# UNITED STATES PATENT AND TRADEMARK OFFICE

APPLICATION NO.	FILING DATE	FIRST NAMED INVENTOR	ATTORNEY DOCKET NO.	CONFIRMATION NO.
09/284,109	04/07/1999	OLEG STOLZ	STOLZ(PCT)	1902

## Office Action Summary

FIG. 1

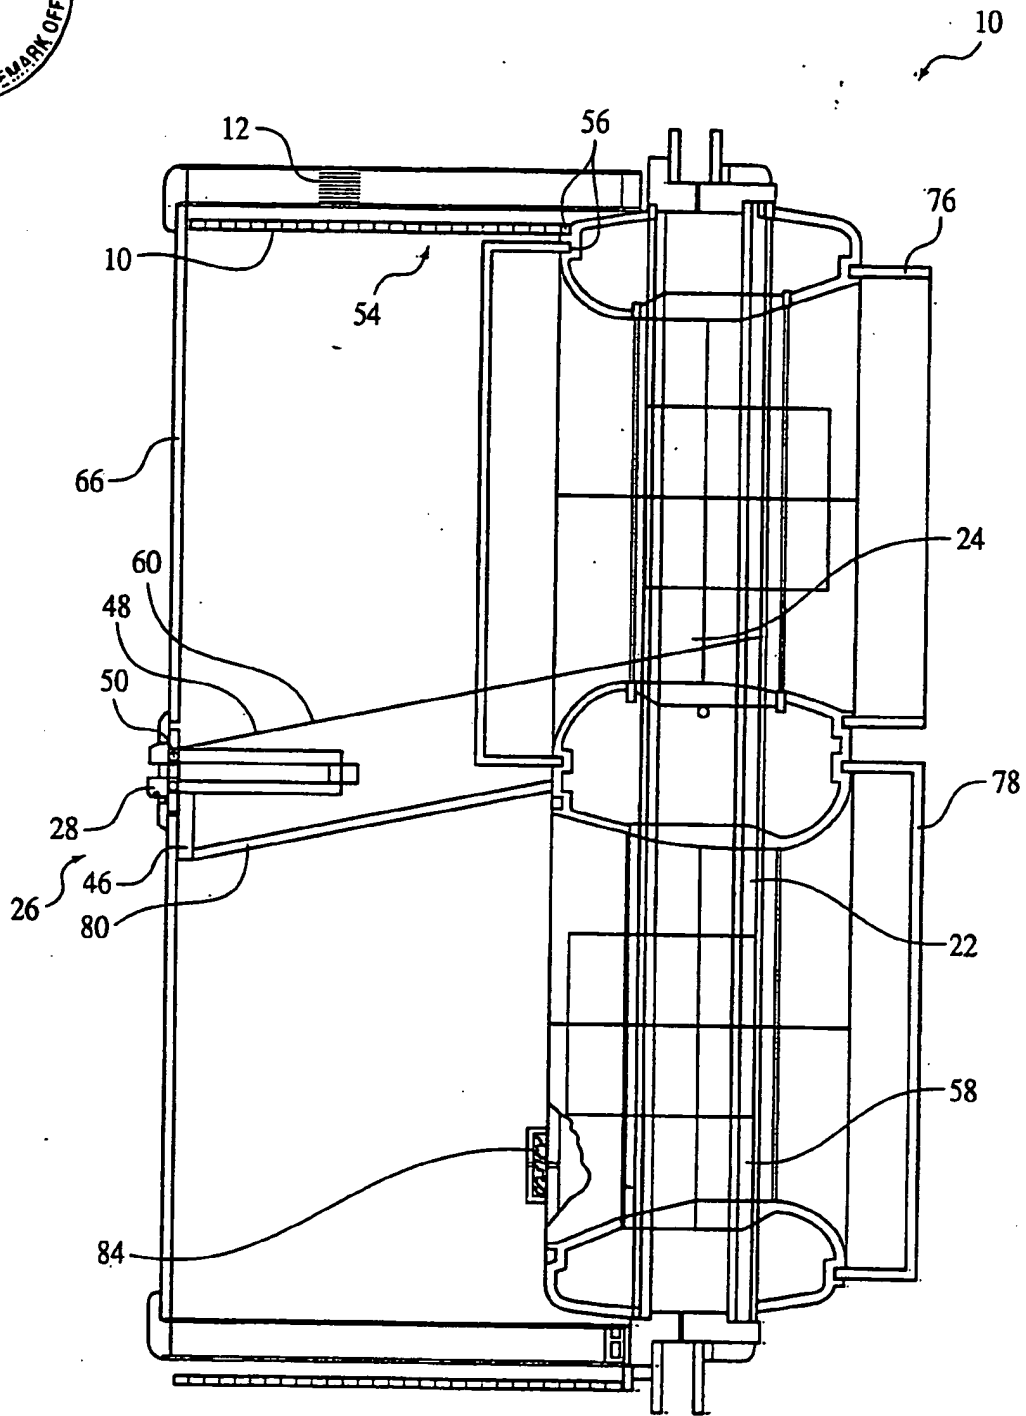
6. The replacement drawings were received on October 12, 2004. These drawings are hereby disapproved because they contain new matter. More particularly, the originally filed disclosure and drawings do not appear to support the particular correspondence between the various elements depicted in the drawings and the element nomenclature in the claims and in the specification via the newly assigned reference characters.

Not  
approved.  
ALC  
4-29-05

FIG. 2

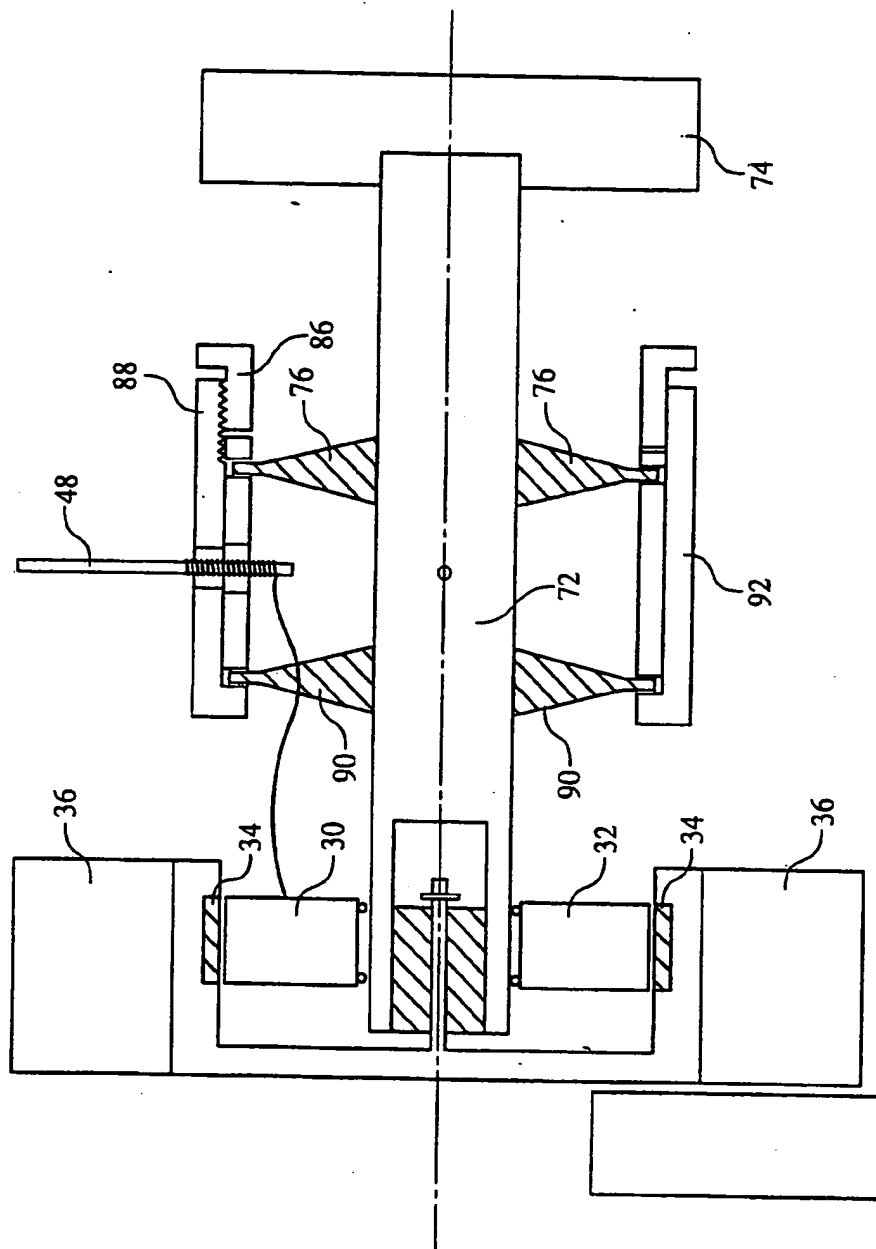
not  
approved:  
LVC  
4-29-05

FIG. 3

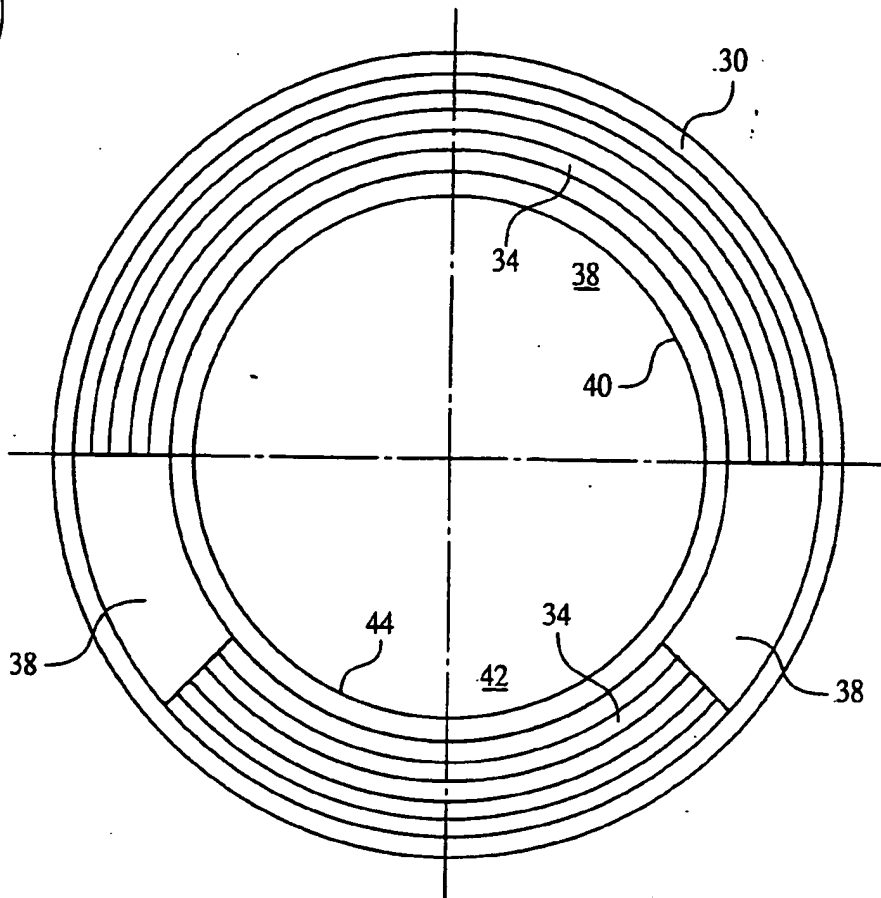
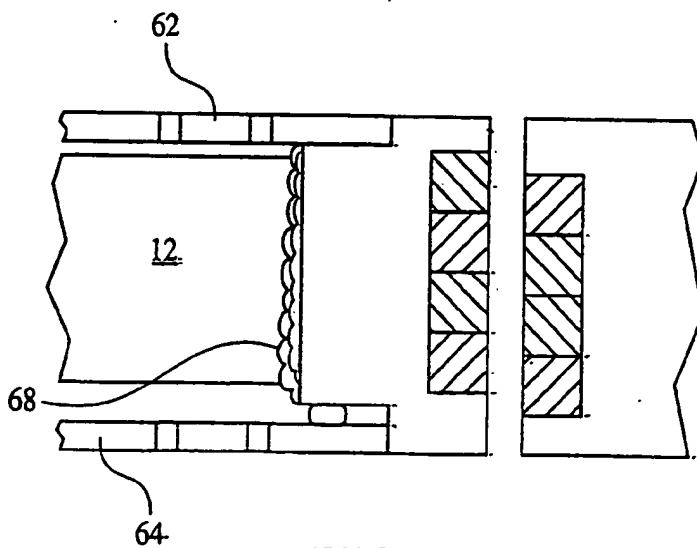
Not  
approved.  
LVC  
4-29-05

FIG. 5

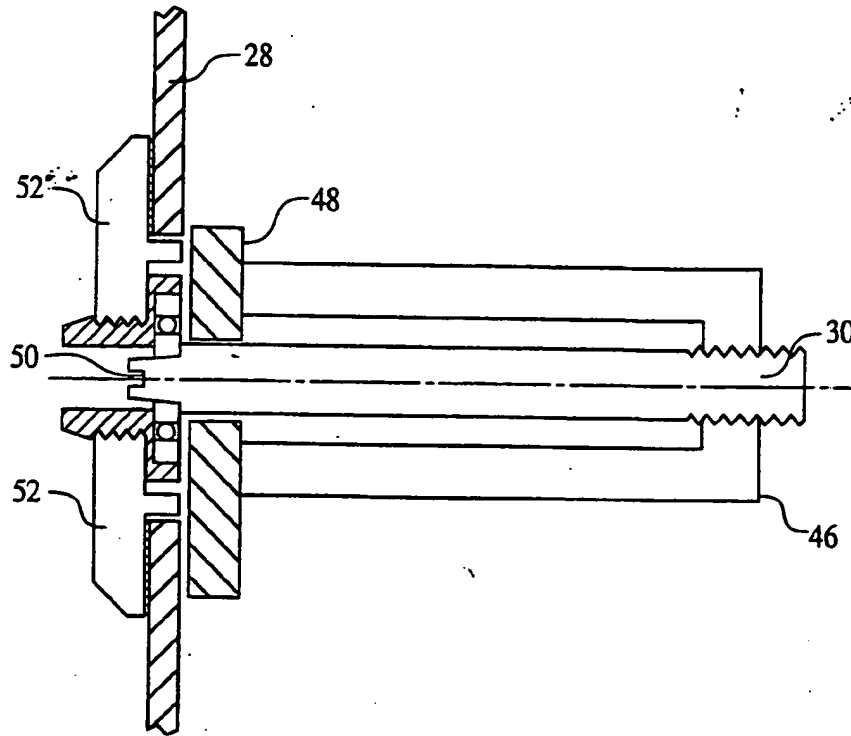
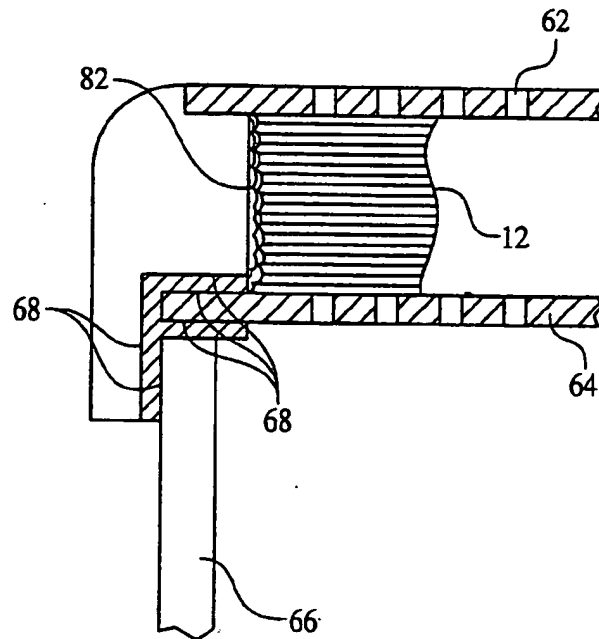
not  
approved.  
FVC  
4-29-05
